Groundwater Application Review Summary Form

Application # G- 19146

PUBLIC INTEREST REVIEW FOR GROUNDWATER APPLICATIONS

A. GENERAL INFORMATION: Applicant's Name: J and J Family LLC County: Marion

Well 5

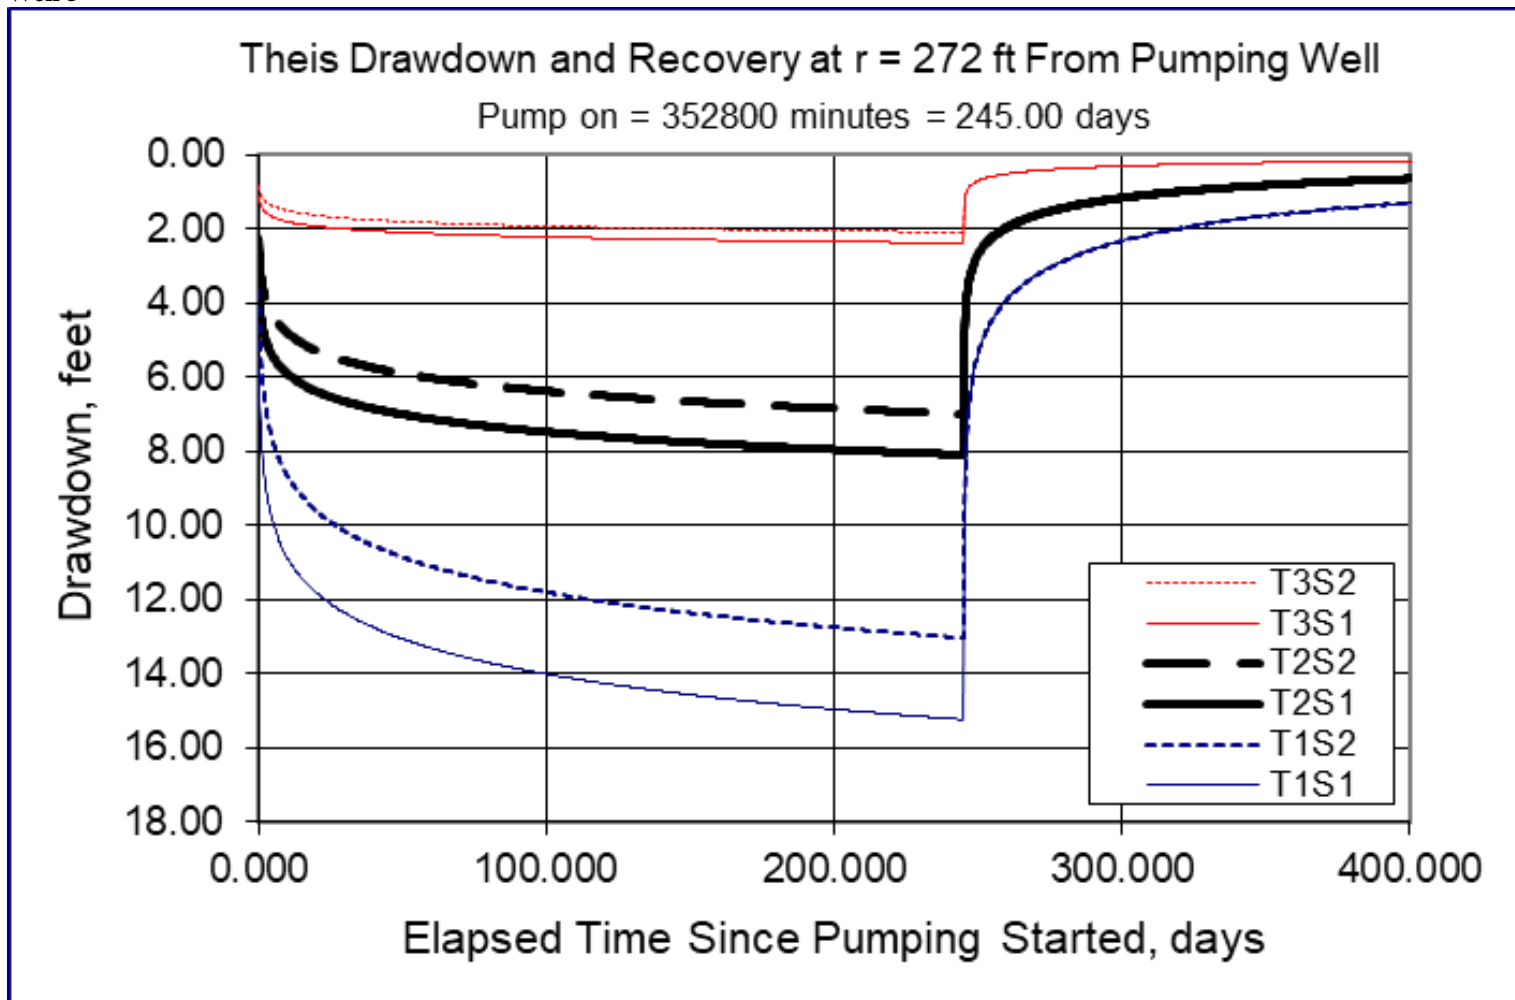
The nearest CRB groundwater user to the proposed location for POA 5 is MARI 7682 (an exempt domestic well), located ~308 ft to the southeast of the POA, at an elevation of 272 ft msl. The well log does not record the latitude or longitude for MARI 7682, but the owner name and location matches taxlot 500. Without additional location information, it was assumed the well is located at the center of the taxlot. MARI 7682 utilizes a WBZ from 76 to 128 ft bls [144 to 196 ft msl]. The proposed seal depth of 50 ft bls [220 ft msl] may be adequate for POA 5, as the well log for MARI 7682 reports a confining layer of hard gray basalt from 37 to 76 ft bls [196-235 ft msl]. It is likely the proposed use would cause some degree of well-to-well interference with MARI 7682. To assess the degree of drawdown, a Theis drawdown analysis was conducted for the proposed use (see attached Theis Drawdown Analysis-Well 5). Results indicate that the proposed use of POA 5 is not likely to cause well-to-well interference with MARI 7682 that exceeds the threshold under the standard condition for basalt aquifers in the Willamette Basin.

Well 6

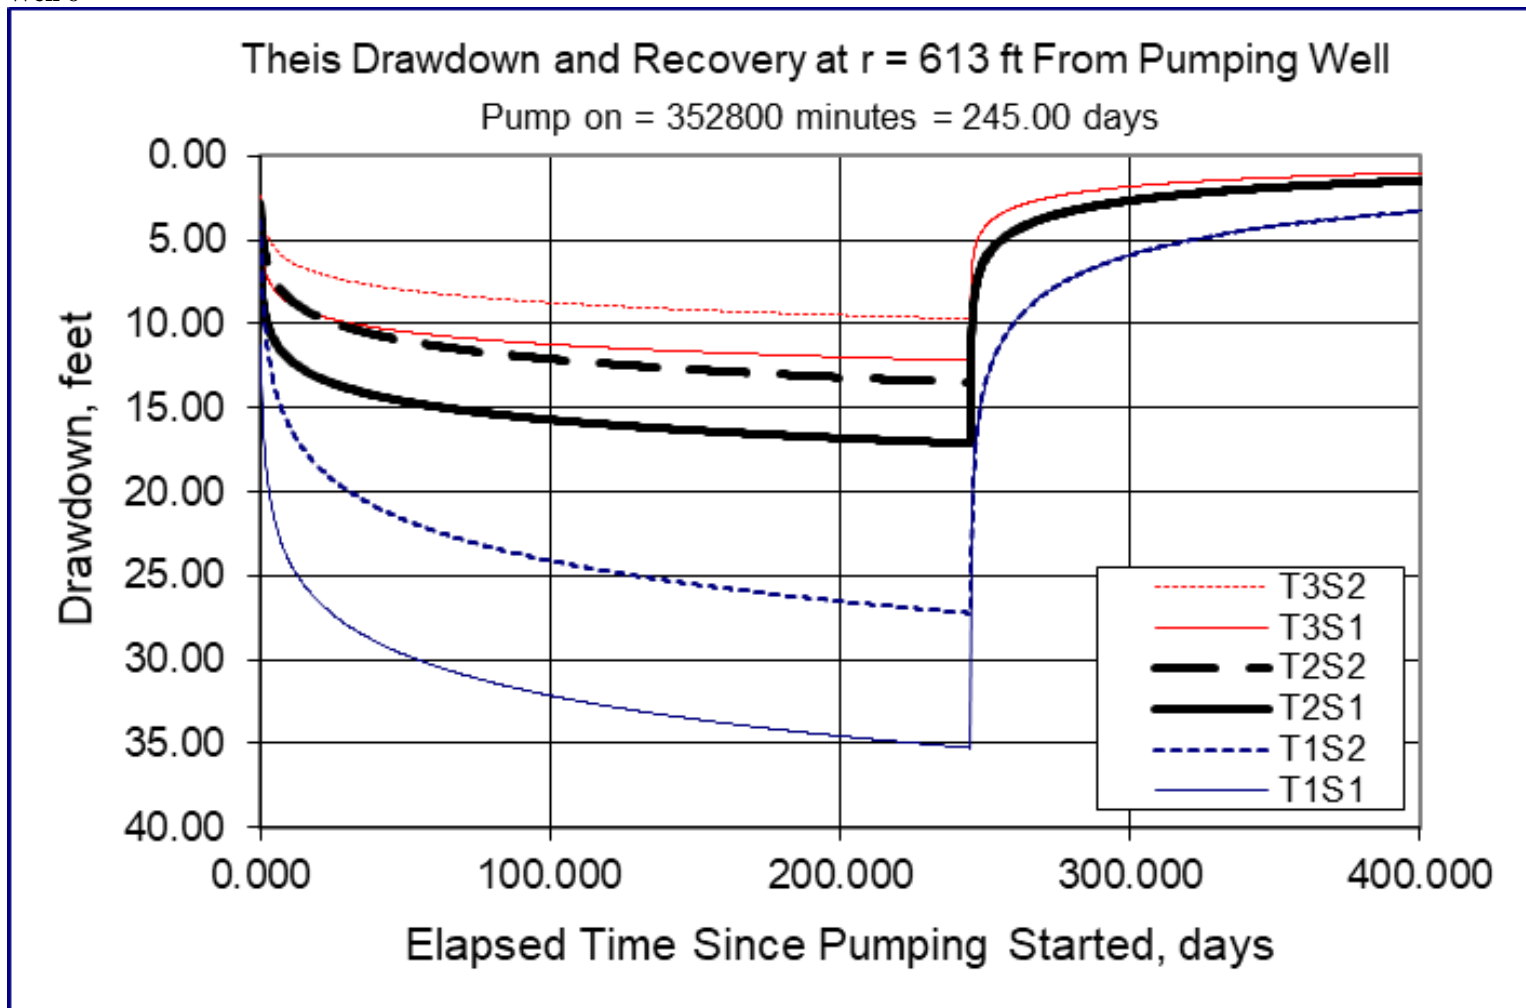
The nearest alluvial groundwater user to the proposed location for POA 6 is MARI 4416 (an exempt domestic well), located ~613 ft to the northwest of the POA, at an elevation of 195 ft msl. The well log does not record the latitude or longitude for MARI 4416, but the owner name, address, and location matches taxlot 900. Without additional location information, it was assumed the well is located at the center of the developed portion of the taxlot. MARI 4416 utilizes a WBZ from 125 to 134

ft bls [61 to 70 ft msl]. It is likely the proposed use would cause some degree of well-to-well interference with MARI 4416. To assess the degree of drawdown, a Theis drawdown analysis was conducted for the proposed use (see attached Theis Drawdown Analysis-Well 6). Results indicate that the proposed use of POA 6 is not likely to cause well-to-well interference with MARI 4416 that exceeds the threshold under the standard condition for alluvial aquifers in the Willamette Basin.

Well 7

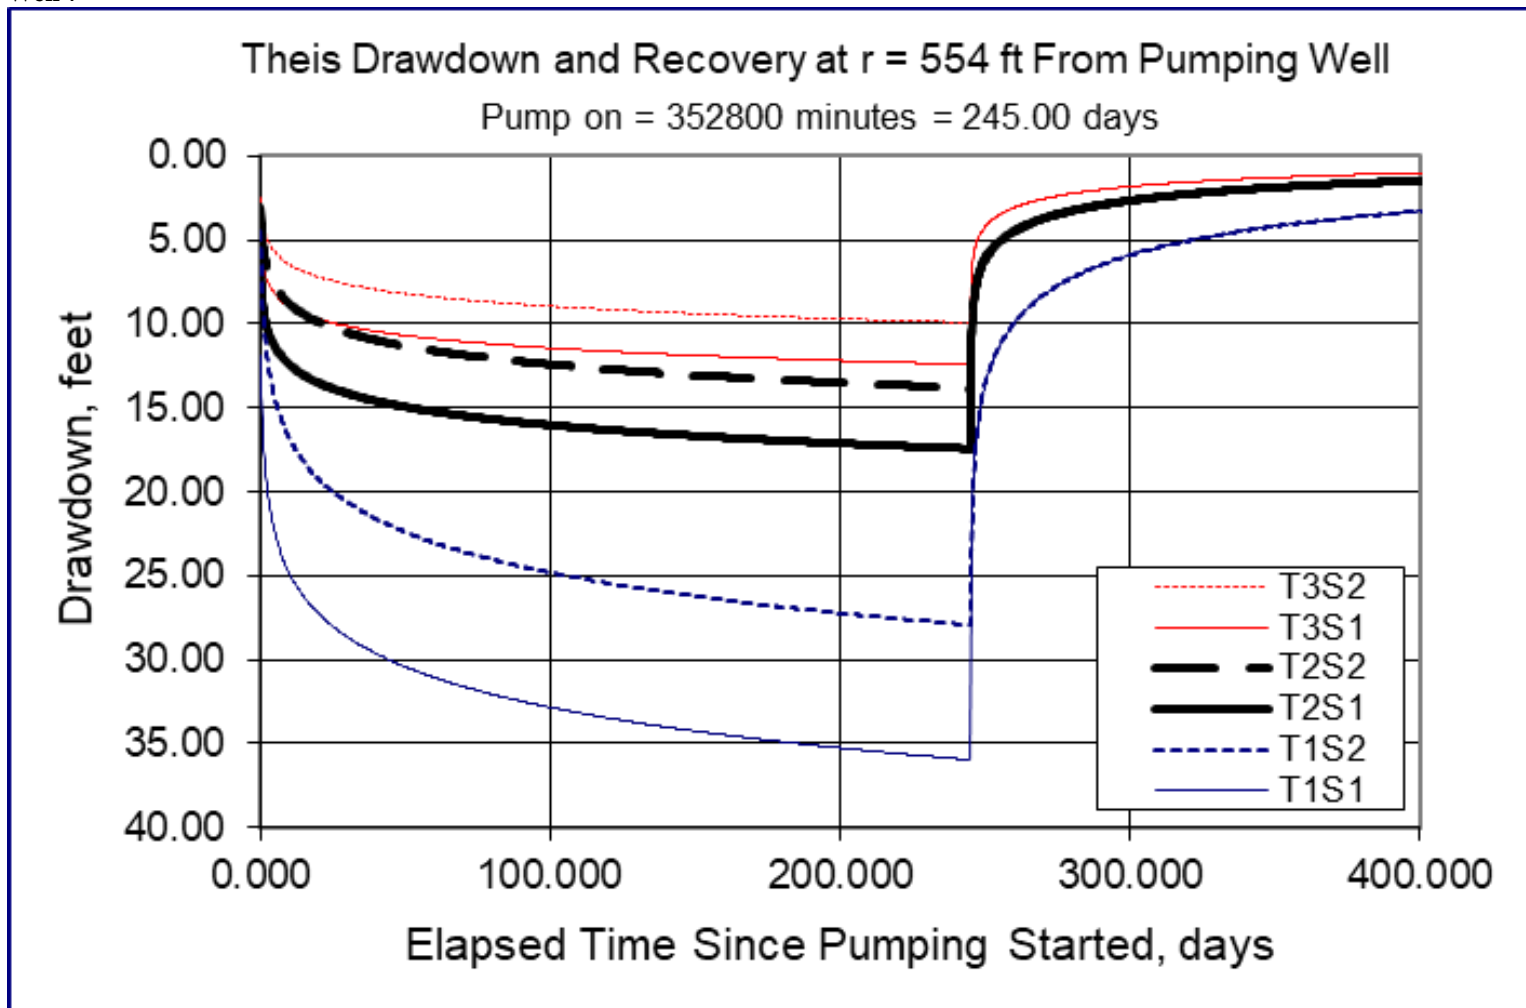
The nearest alluvial groundwater user to POA 7 is MARI 60440 (an exempt domestic well), located ~554 ft to the southeast of the POA, at an elevation of 202 ft msl. MARI 60440 utilizes a WBZ from 90 to 160 ft bls [42 to 112 ft msl]. It is likely the proposed use would cause some degree of well-to-well interference with MARI 60440. To assess the degree of drawdown, a Theis drawdown analysis was conducted for the proposed use (see attached Theis Drawdown Analysis-Well 7). Results indicate that the proposed use of POA 7 is not likely to cause well-to-well interference with MARI 60440 that exceeds the threshold under the standard condition for alluvial aquifers in the Willamette Basin.

Well 8

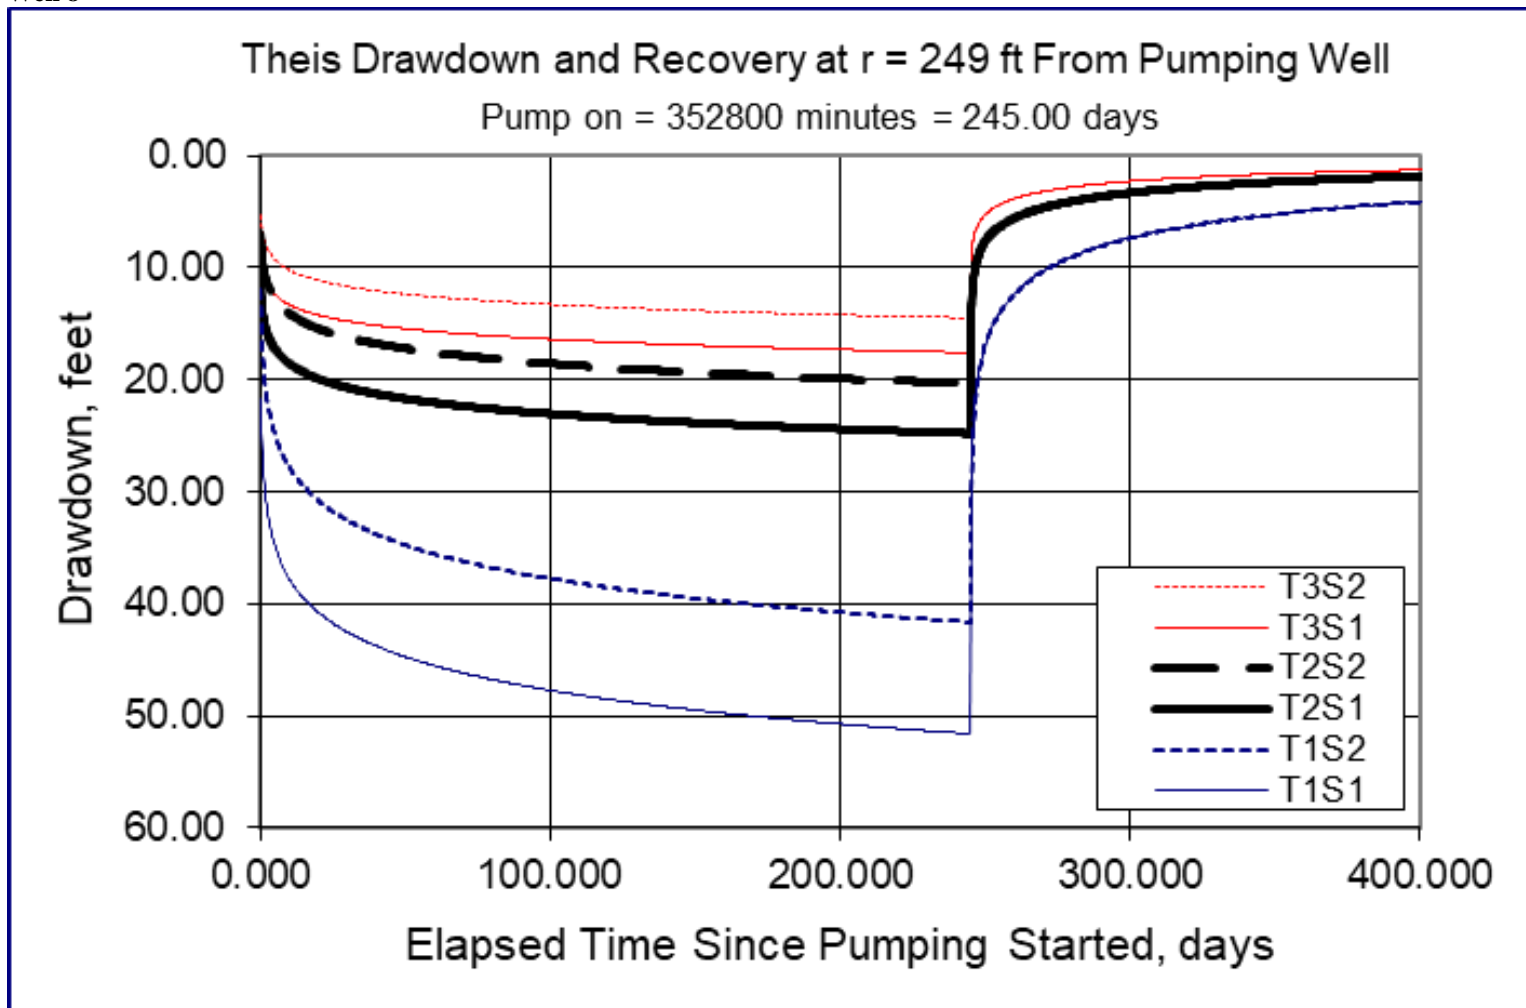
The nearest alluvial groundwater user to POA 8 is MARI 50725 (G-1572 and G-4495 via T-7553 with priority dates 4/11/1960 and 1/24/1969), located ~249 ft to the southwest of the POA, at an elevation of 205 ft msl. MARI 50725 utilizes a WBZ from 68 to 222 ft bls [-17 to 137 ft msl]. It is likely the proposed use would cause some degree of well-to-well interference with MARI 50725. To assess the degree of drawdown, a Theis drawdown analysis was conducted for the proposed use (see attached Theis Drawdown Analysis-Well 3). Results indicate that the proposed use of POA 8 is not likely to cause well-to-well interference with MARI 50725 that exceeds the threshold under the standard condition for alluvial aquifers in the Willamette Basin.
